**City of Portland, Maine – Building or Use Permit Application** 389 Congress Street, 04101, Tel: (207) 874-8703, FAX: 874-8716

**BUILDING PERMIT REPORT**

DATE: 11 APRIL 2000 ADDRESS: Lot #25 Auburn Pines CBL: 386A-B-025  
REASON FOR PERMIT: Single Family dwelling with attached garage  
BUILDING OWNER: Dona Telle  
PERMIT APPLICANT: \_\_\_\_\_ / CONTRACTOR owner  
USE GROUP: R-3 CONSTRUCTION TYPE: 5-B CONSTRUCTION COST: 170,000.00 PERMIT FEES: 864.00

**CITY OF PORTLAND, ME  
BOCA 1999 Plan Review Record  
One and Two Family Dwelling**

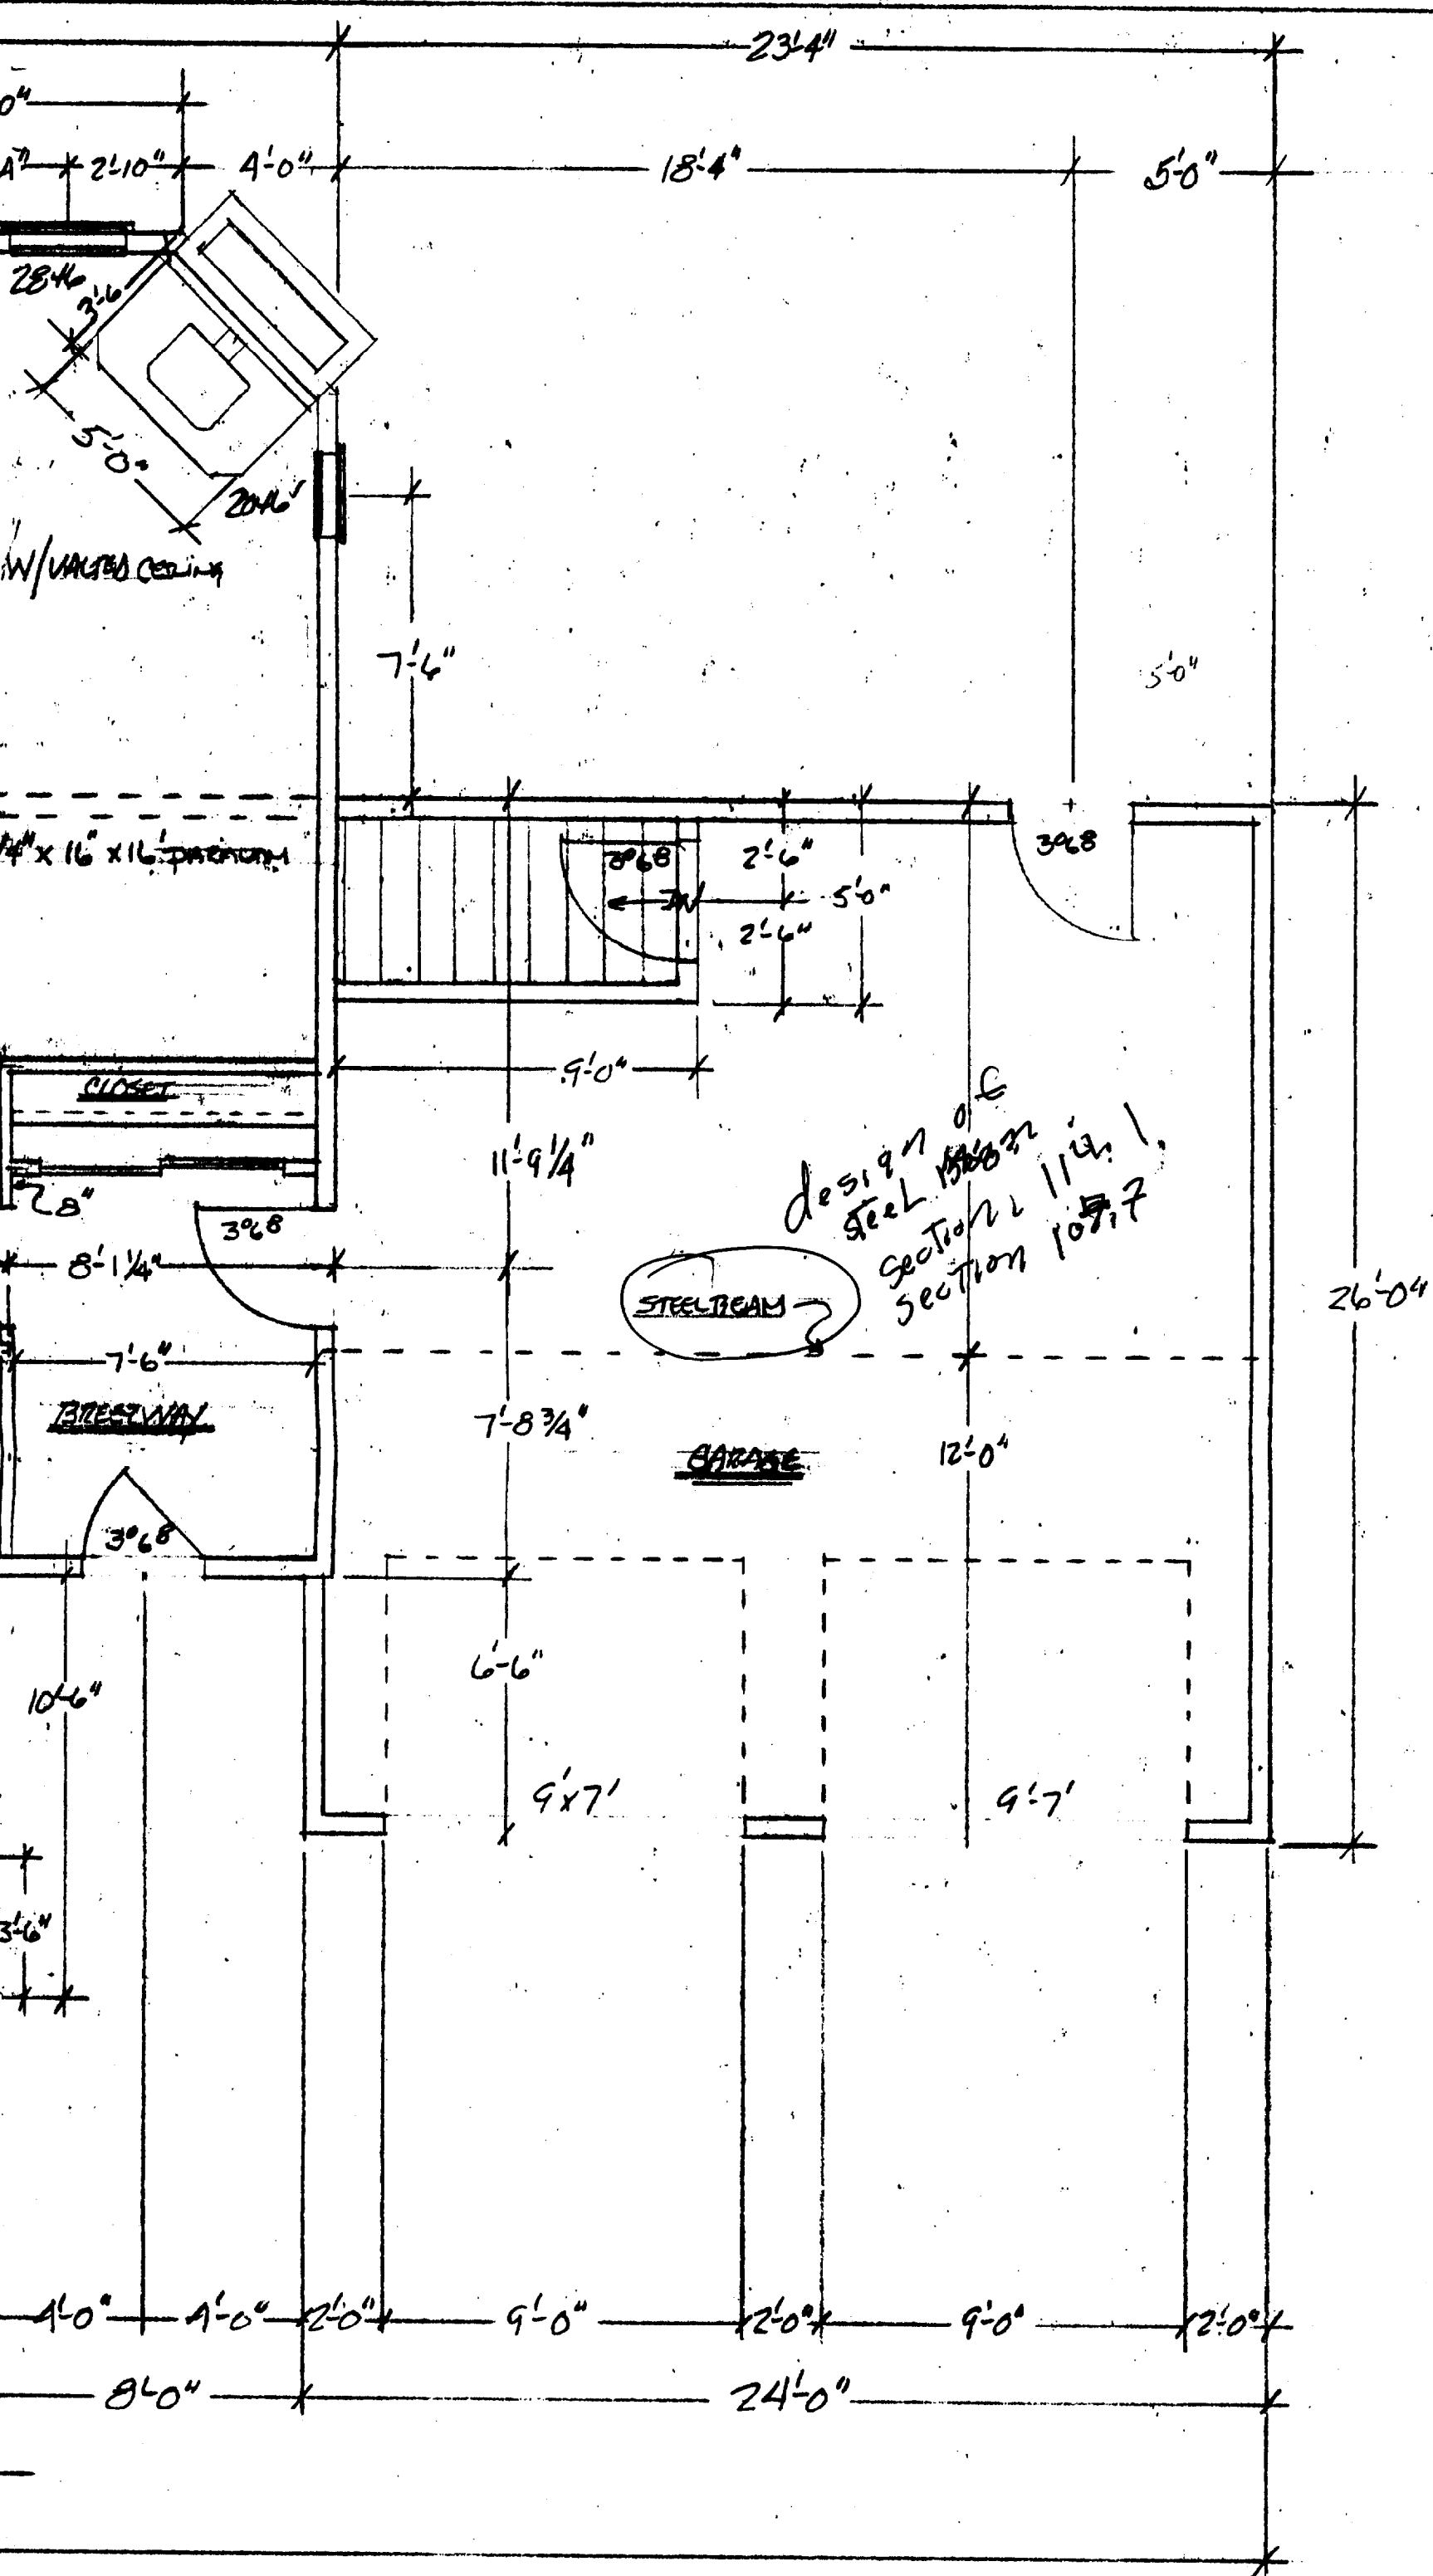
NSPA  
#211

NSPA  
#211

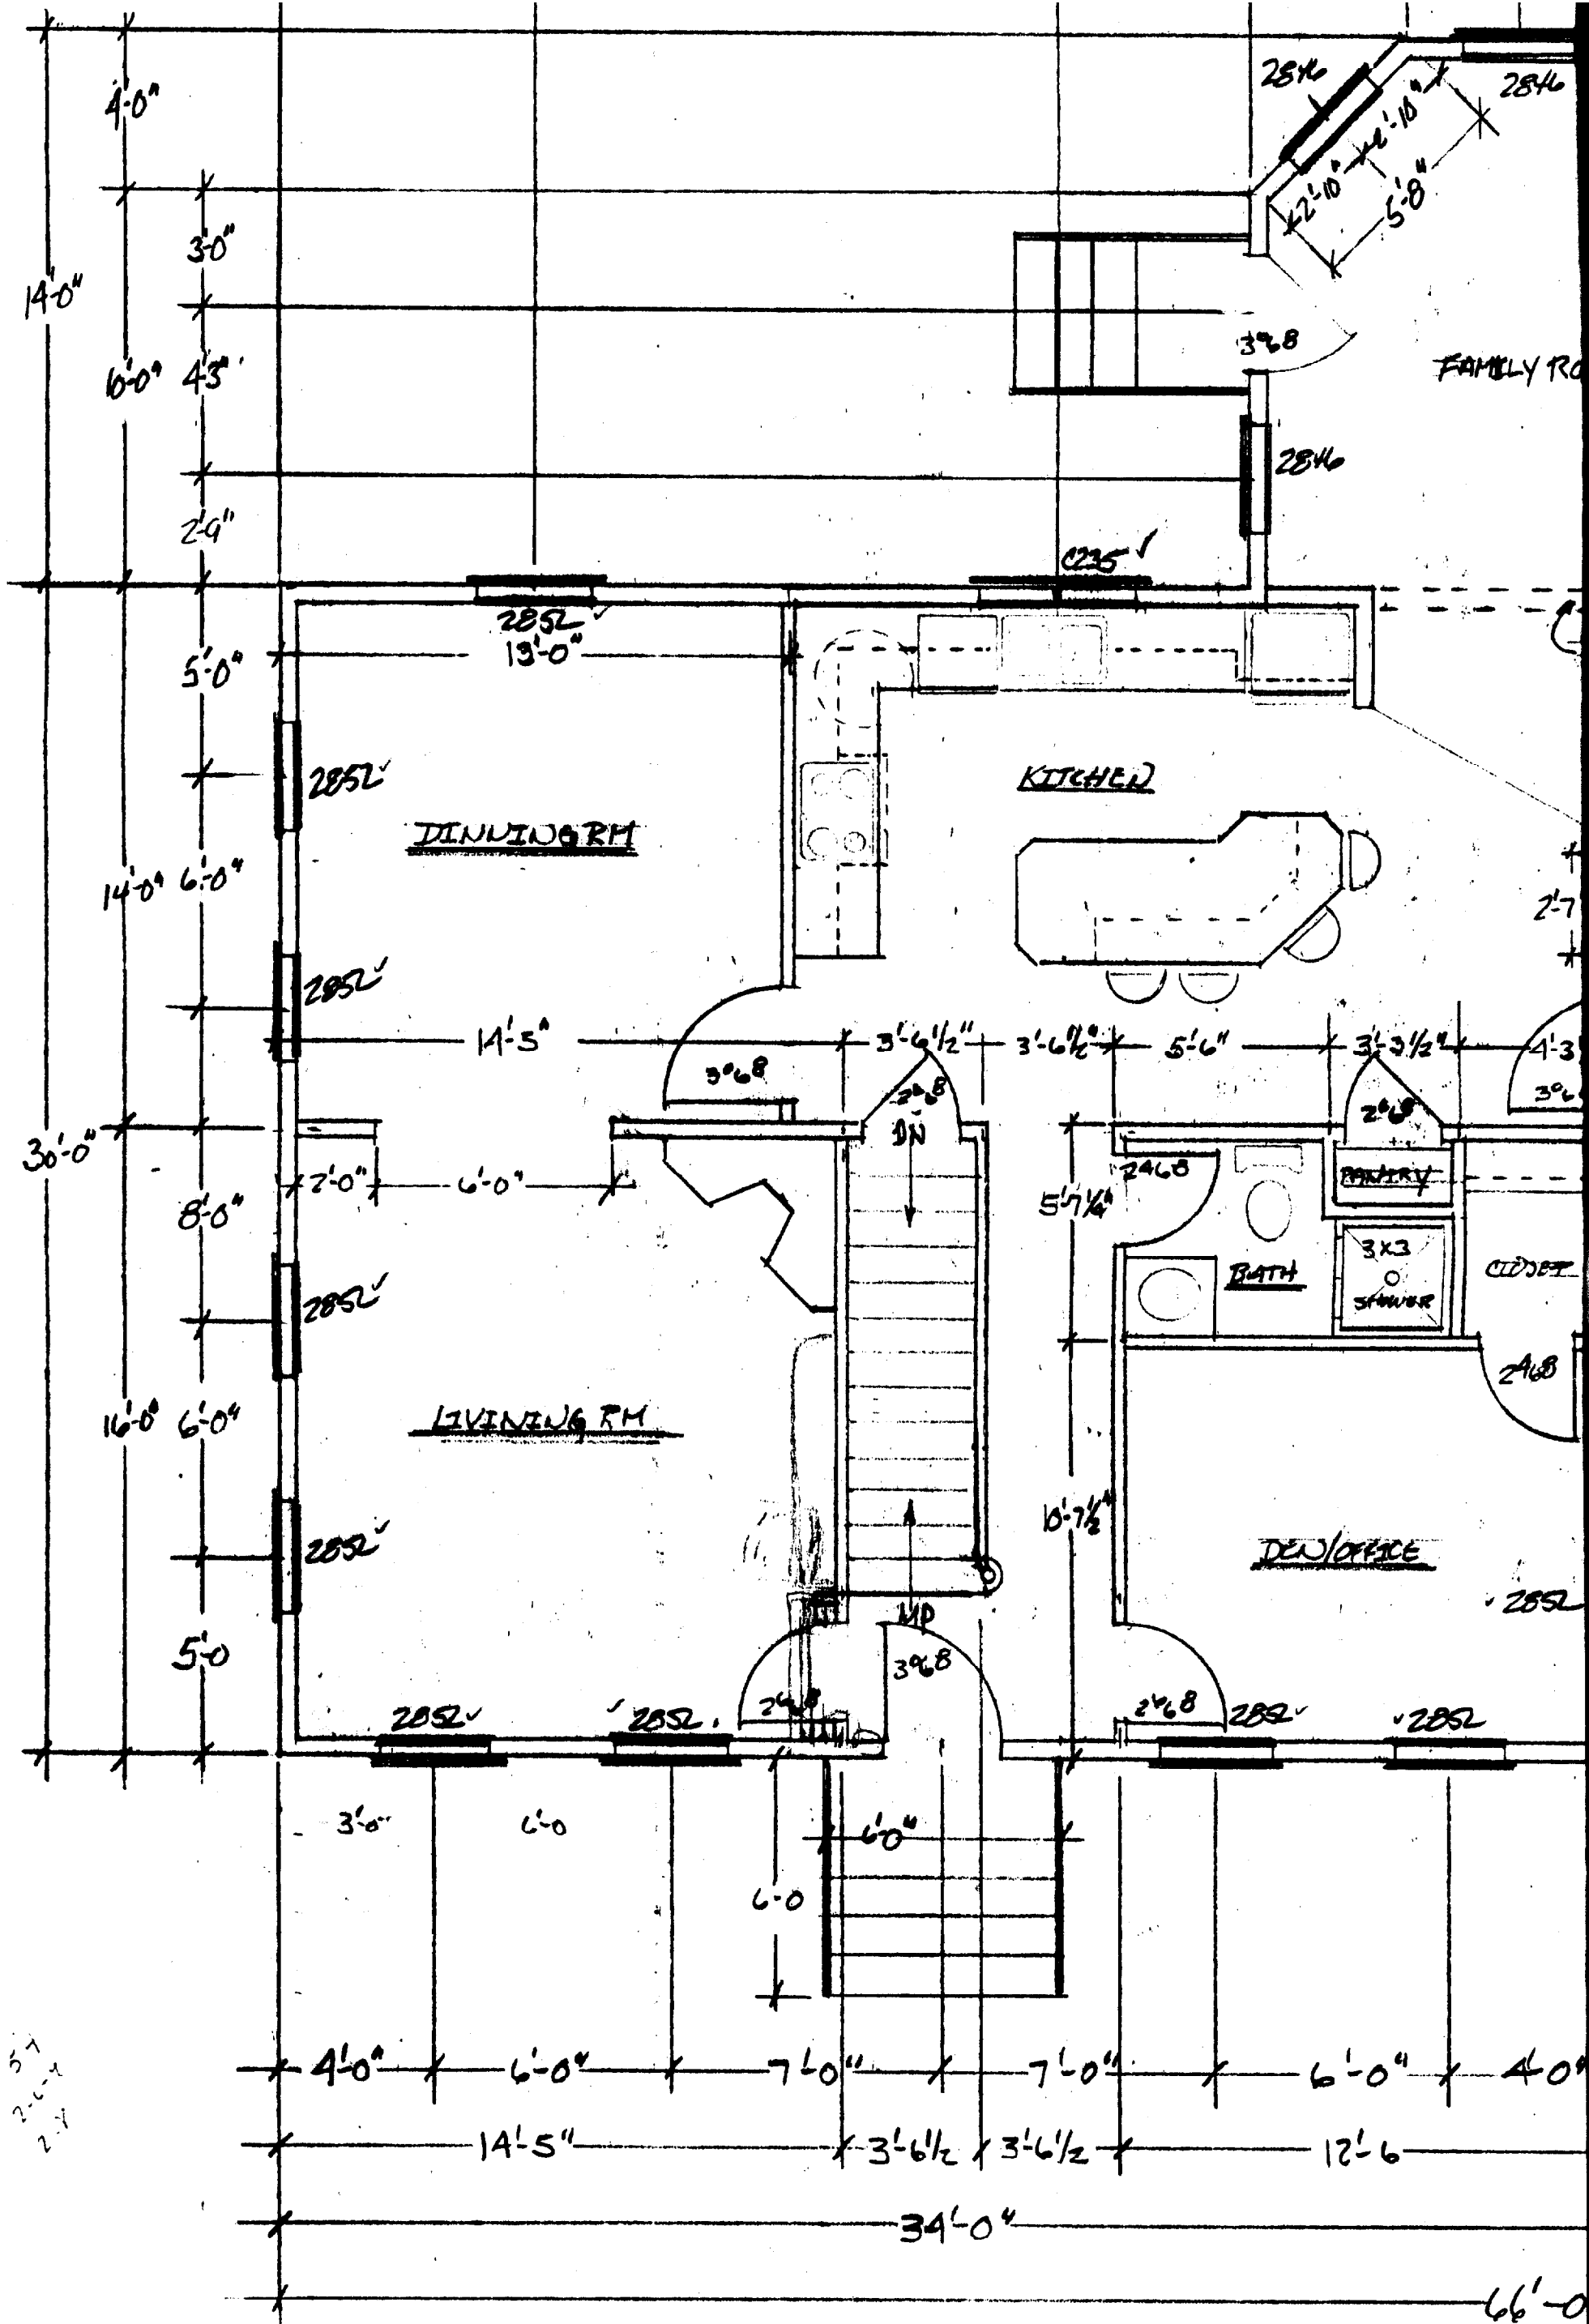
NO  
Deck  
or stairs  
shown
